VCBO® ADDENDUM 001

project	Intermountain PKH Sports Performance Center Phase 2	project no	20065.01
date	2023-10-25	no. pages	
owner	Intermountain Healthcare		
contractor			
bid date	2023-10-30	bid time	4:00 pm

Project: INTERMOUNTAIN PARK CITY HOSPITAL - SPORTS PERFORMANCE CLINIC

Revision: Addendum 001

1 MECHANICAL ZONING PLAN FIRST FLOOR - AREA 1
SCALE: 1/8" = 1'-0"

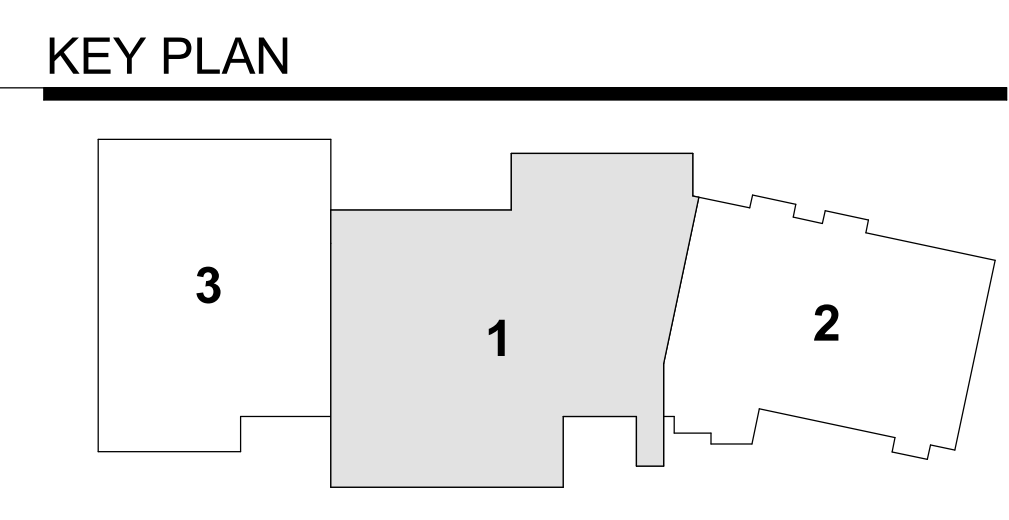
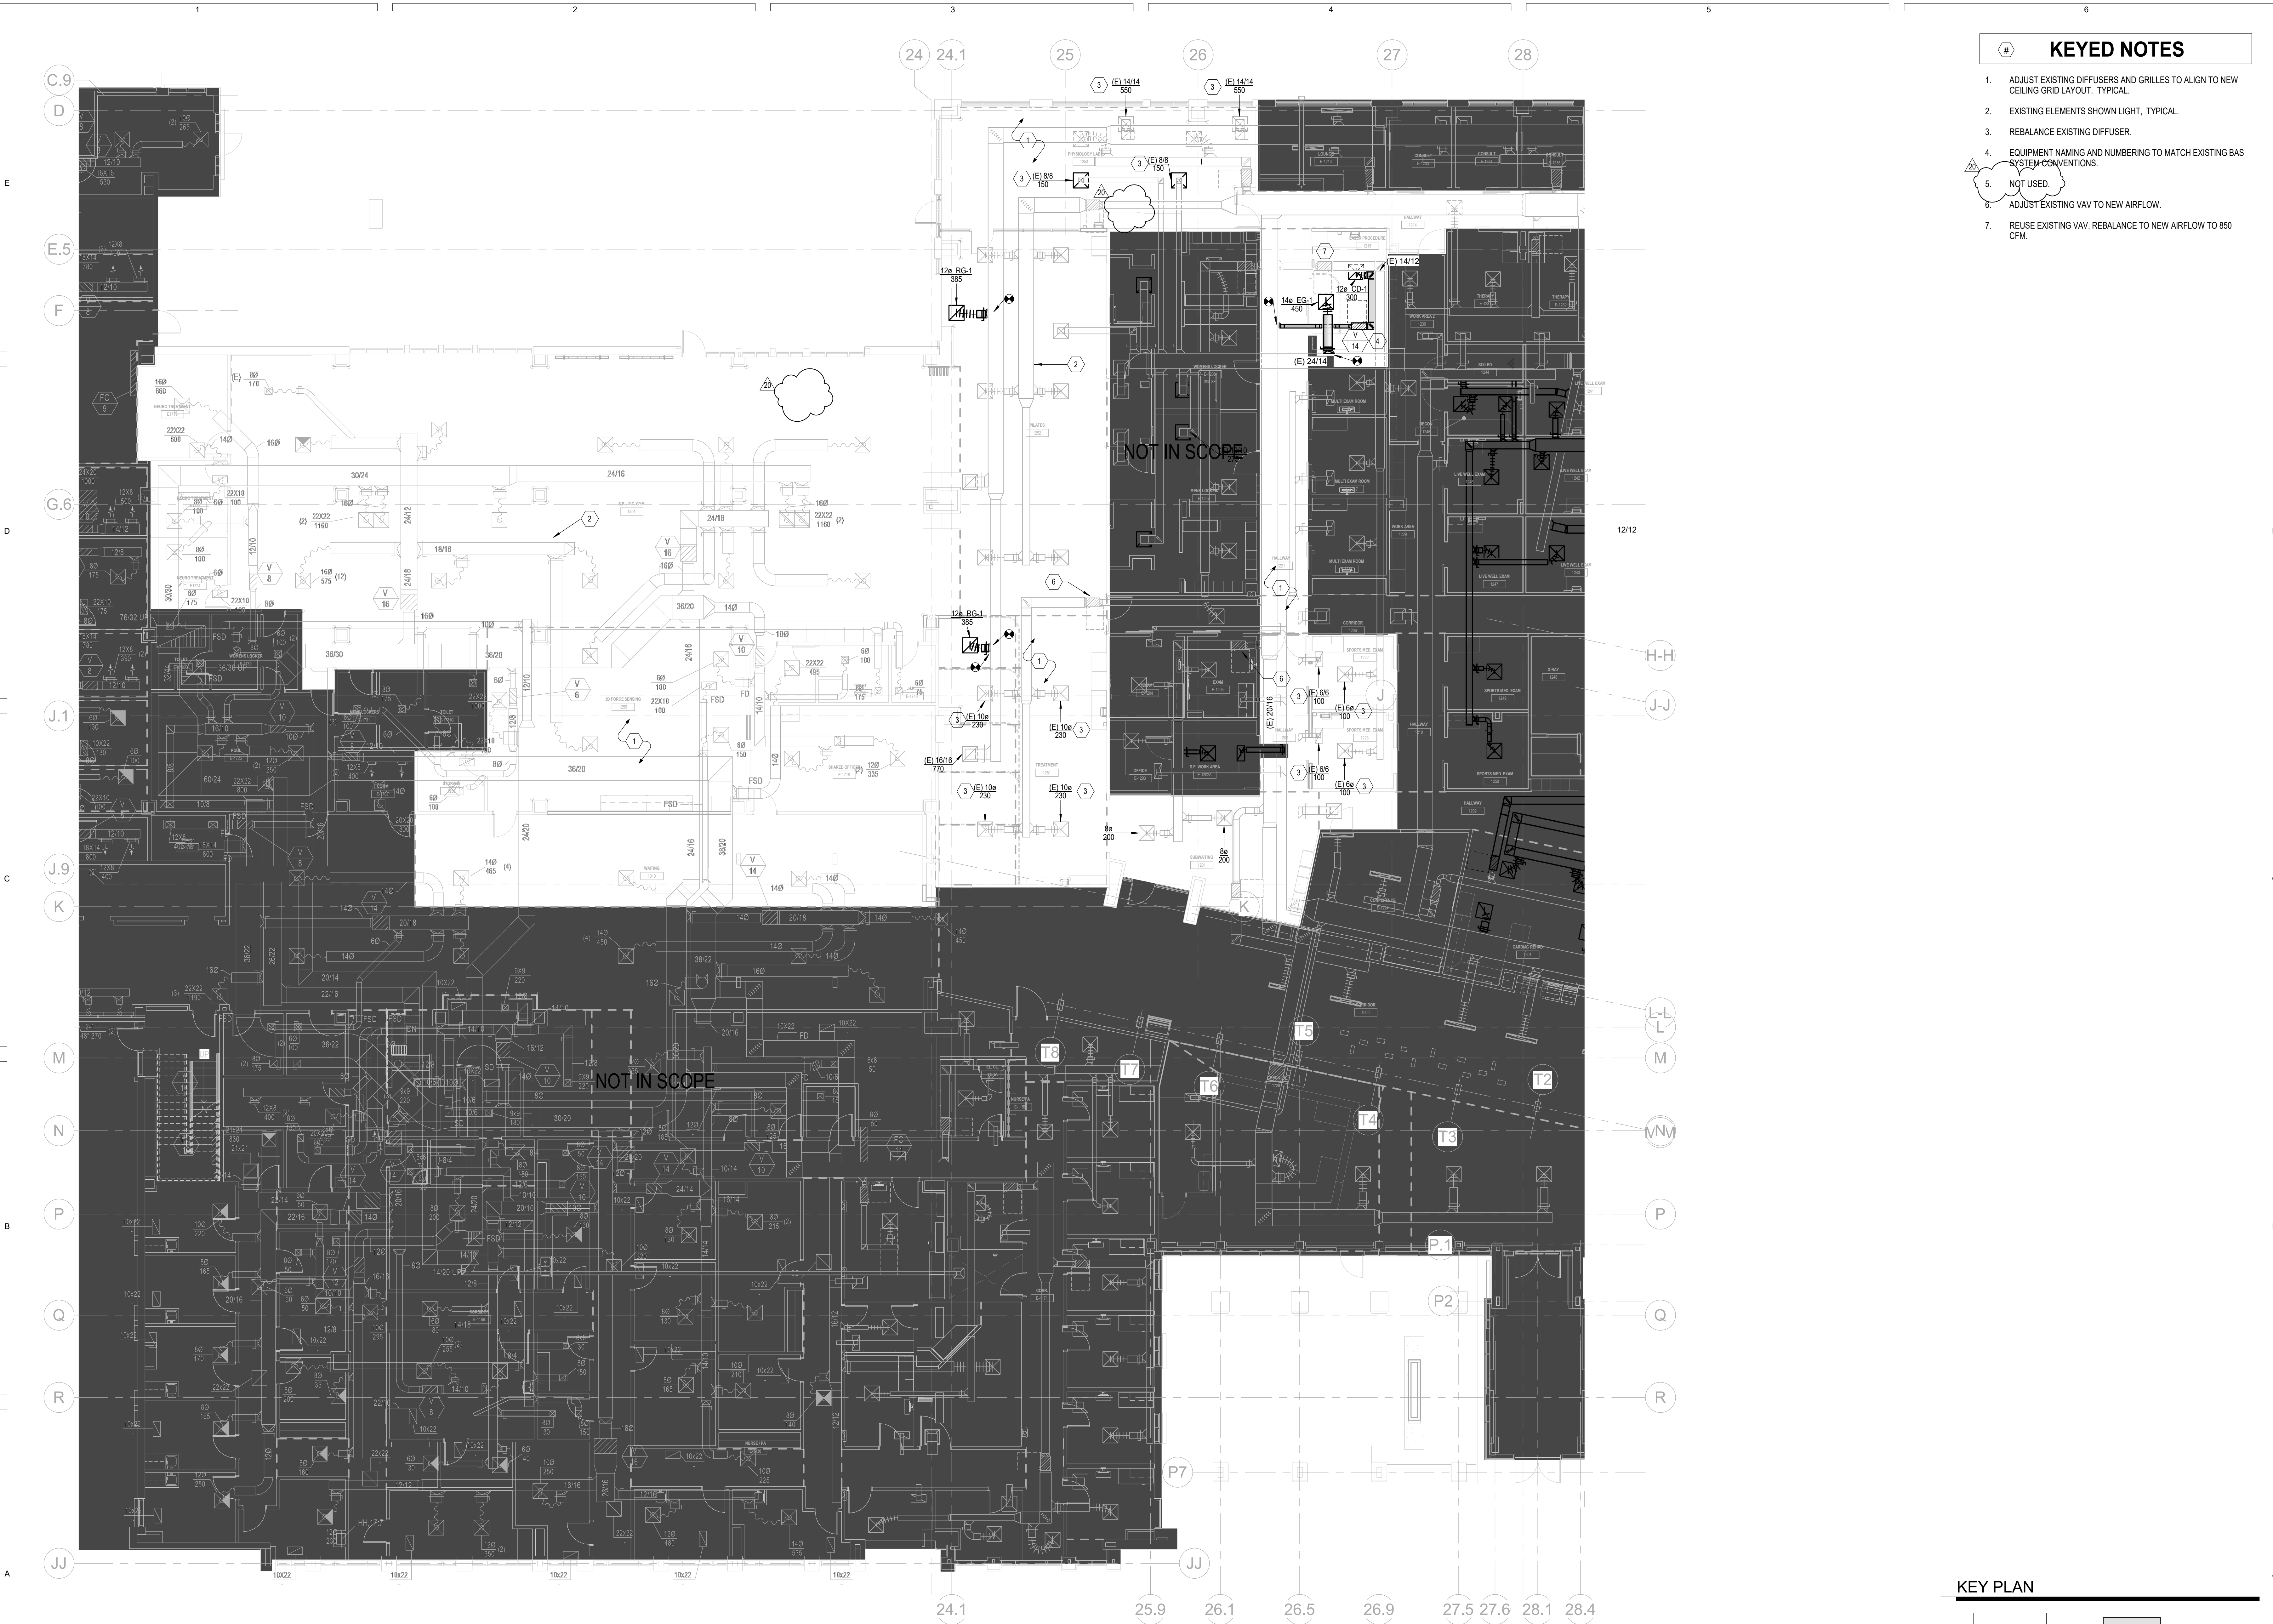
- Relocated thermostat.
- Keyed note 1 added.

1 MECHANICAL PLAN FIRST FLOOR - AREA 1
SCALE: 1/8" = 1'-0"

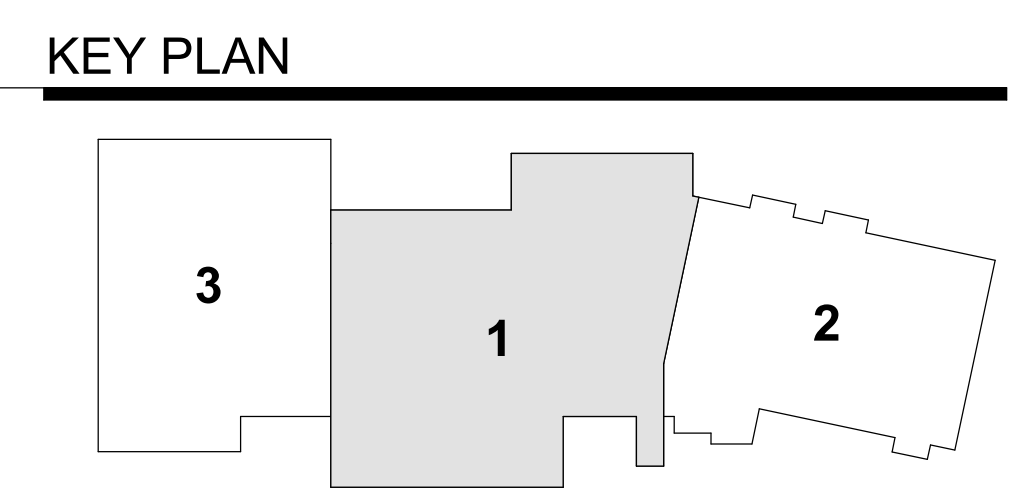
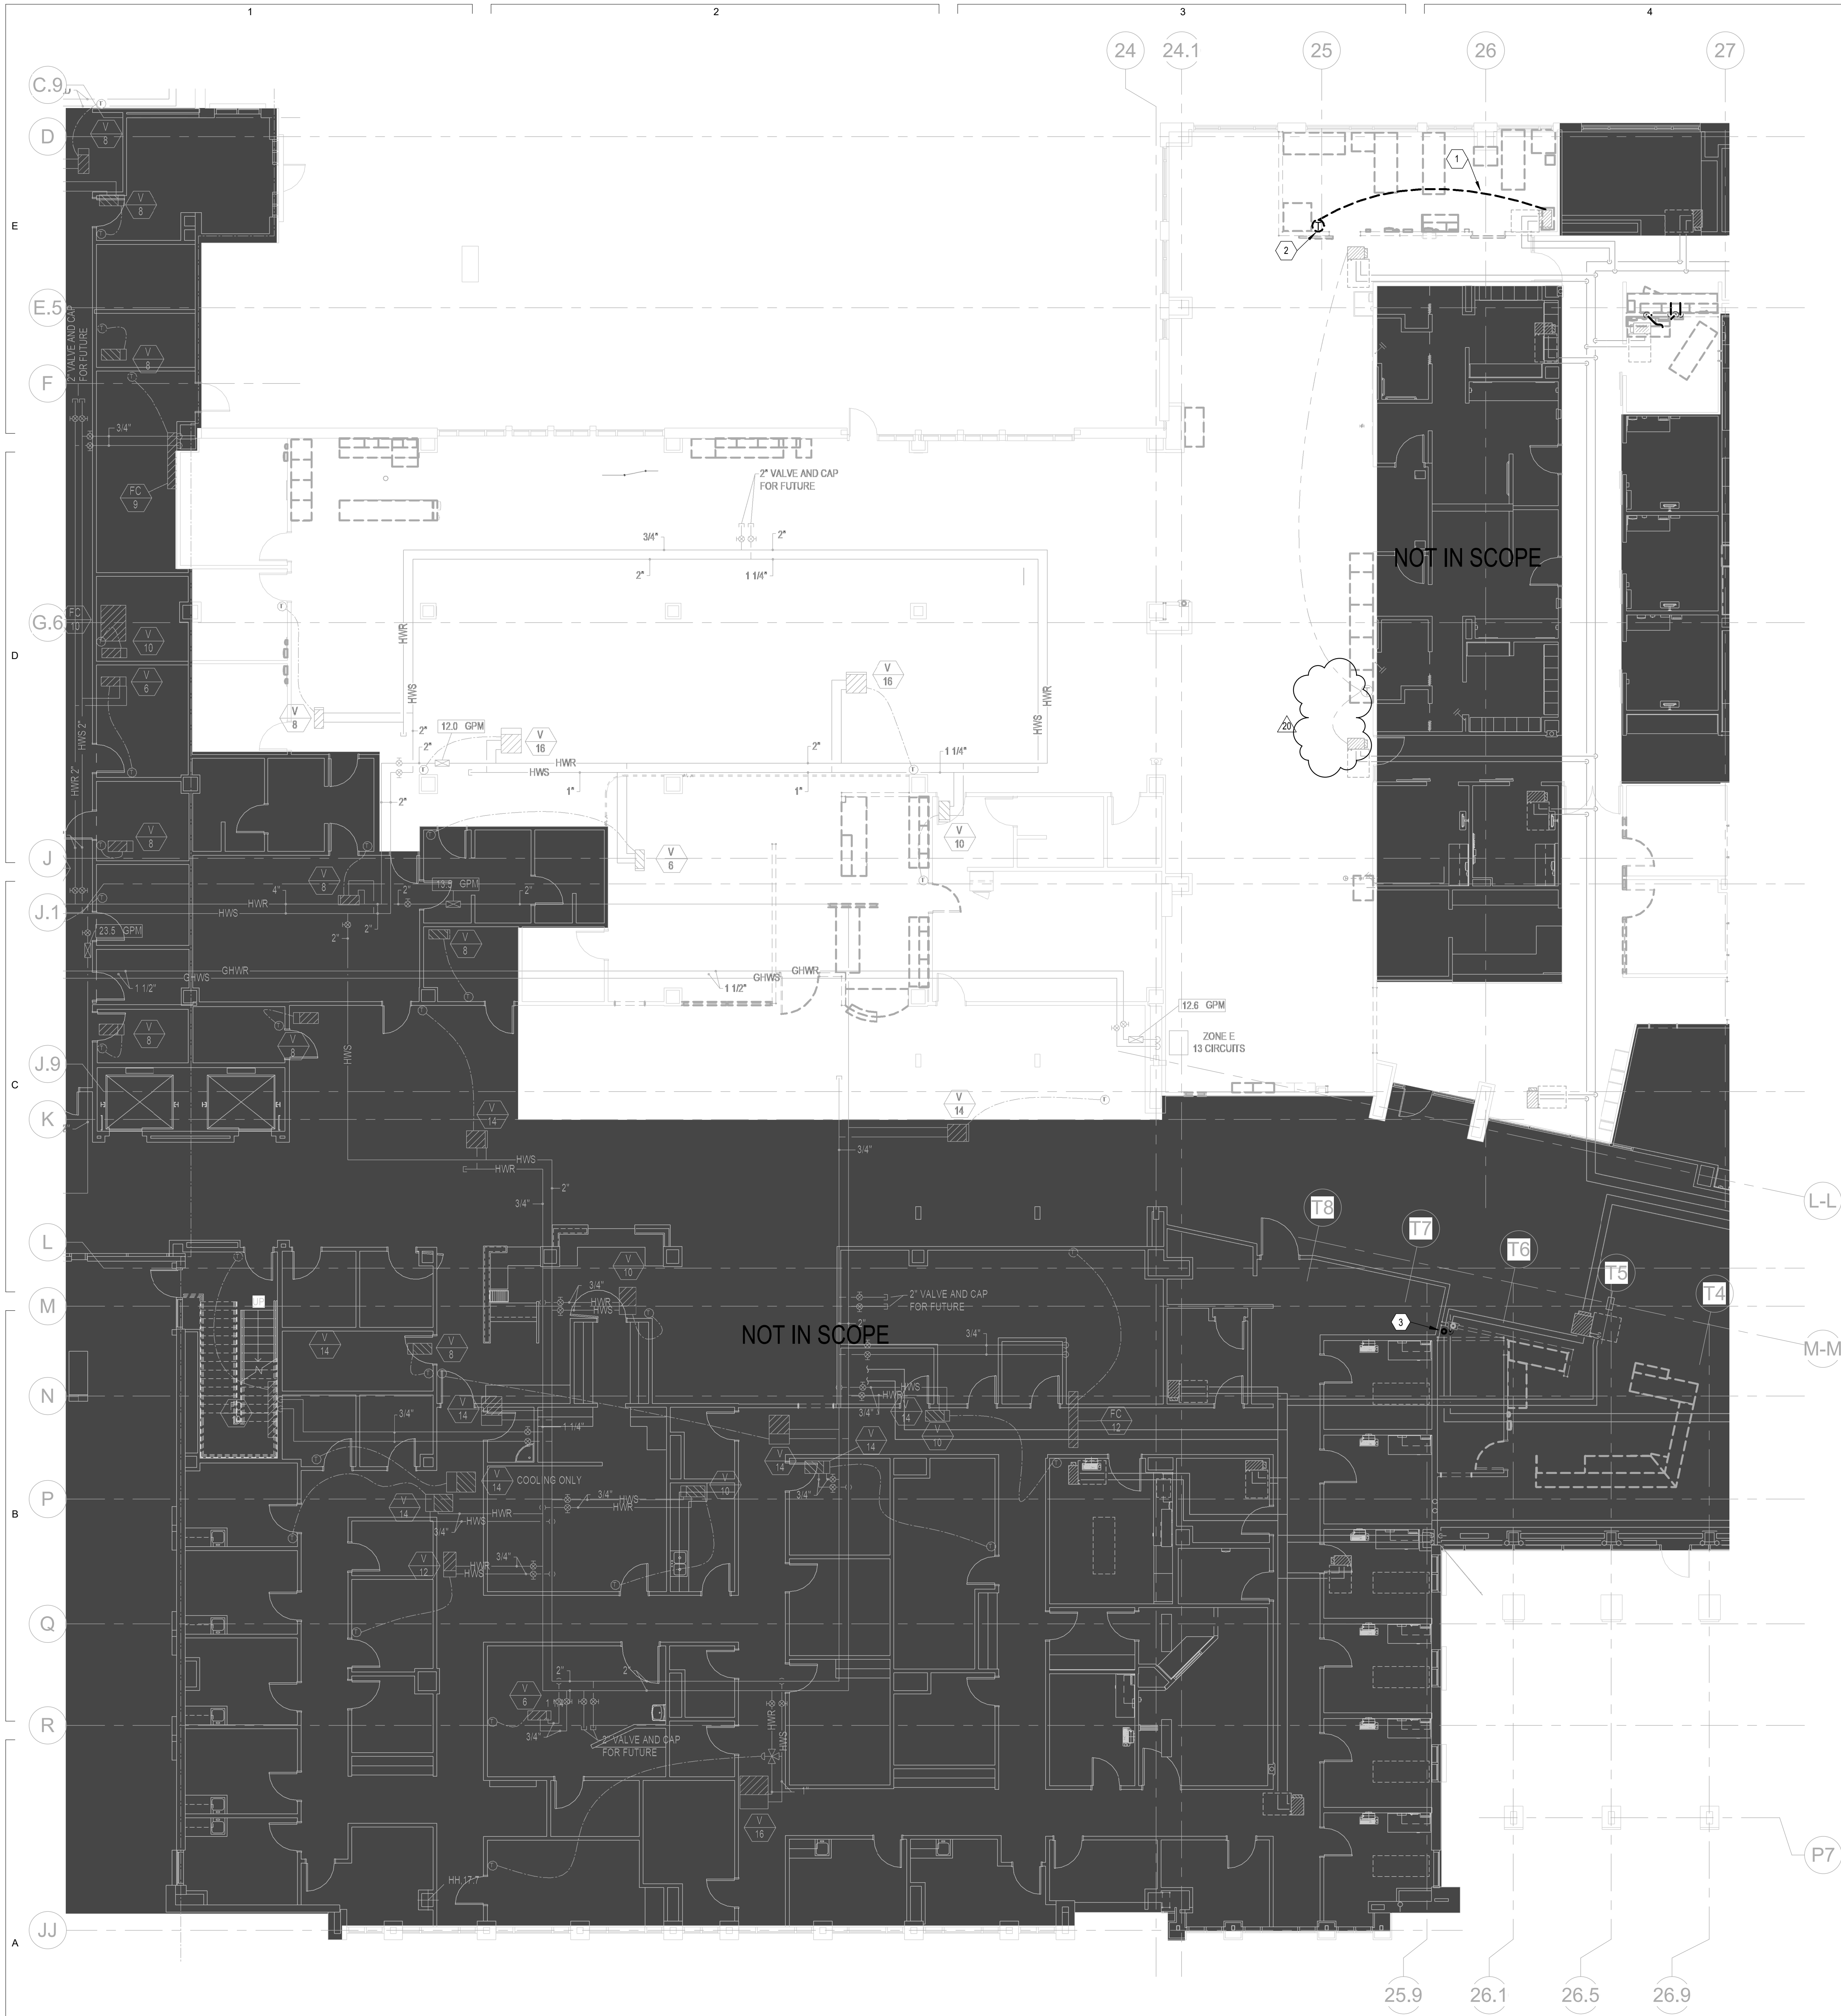
- Keyed note 5 removed from sheet.
